# MT4 JUMPERS

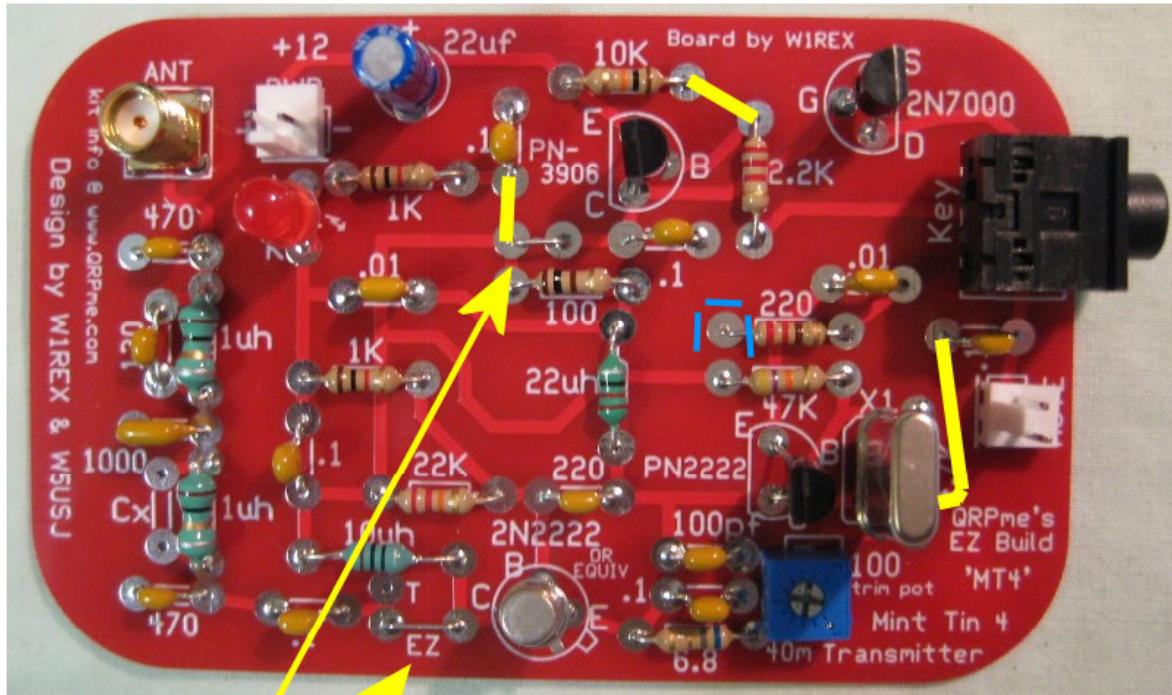
← install 2 original board jumpers

— install 3 new jumpers  
1K-.1uf junction to left pcb jumper pad  
10K right pad to 2.2K top pad  
left .1uf pad to bottom 4.7K pad

┌ remove 3 tiny grounding rays....  
on bottom side on the  
left pad of 220 ohm resistor
